Access Compliance Report

Public Rights-of-Way

Intersection ID: 22096	Main Street: COLONY_RD	Cross Street: CARMEL_CRESCENT_DR	Location: SW
ADA ID: 8262A1187A34	Ramp Type: PerpDiag	Initial Pass/Fail: Fail	Overall Compliance: No
		Severity Score: 8.75

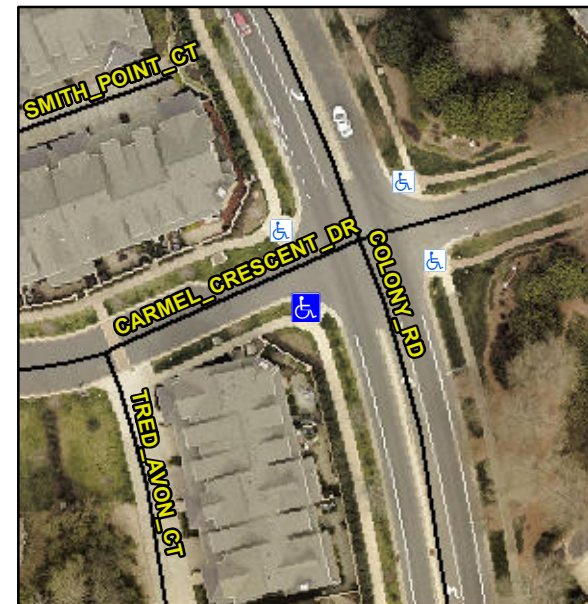
Not Found, R304.5.1

Compliance	Description	Data	Compliance	Description	Data
N/A	Ramp Length (in)	97.0	Yes	Ramp Slope (%)	6.4
No	Ramp Width (in)	41.0	Yes	Ramp XSlope (%)	2.0
N/A	Flare Type LT	N/A	N/A	Flare Type RT	N/A
N/A	Flare Slope LT (%)	N/A	N/A	Flare Slope RT (%)	N/A
N/A	Flare Traversable LT?	N/A	N/A	Flare Traversable RT?	N/A
N/A	Landing Length (in)	N/A	N/A	DWS Provided?	N/A
N/A	Landing Width (in)	N/A	N/A	DWS Contrast?	N/A
N/A	Landing Slope (%)	N/A	N/A	DWS Length (in)	N/A
N/A	Landing X Slope (%)	N/A	N/A	DWS Full Width?	N/A
N/A	Landing Curb? (Y/N)	N/A	N/A	DWS Offset (in)	N/A
N/A	Shared Landing?	N/A			
N/A	Gutter Ponding?	N/A	N/A	Gutter Slope (%)	N/A
N/A	Gutter Lip Ht (in)	N/A	N/A	Gutter X Slope (%)	N/A
N/A	Painted X Walk1?	No	N/A	Painted X Walk2?	No
	X Walk 1 Direction	To E		X Walk 2 Direction	To N
N/A	X Walk 1 Width (in)	N/A	N/A	X Walk 2 Width (in)	N/A
	X Walk 1 Slope (%)	2.8		X Walk 2 Slope (%)	3.7
	X Walk 1 X Slope (%)	4.2		X Walk 2 X Slope (%)	3.7

Remove & Replace Curb Ramp With Two New Directional Ramps or Equivalent.
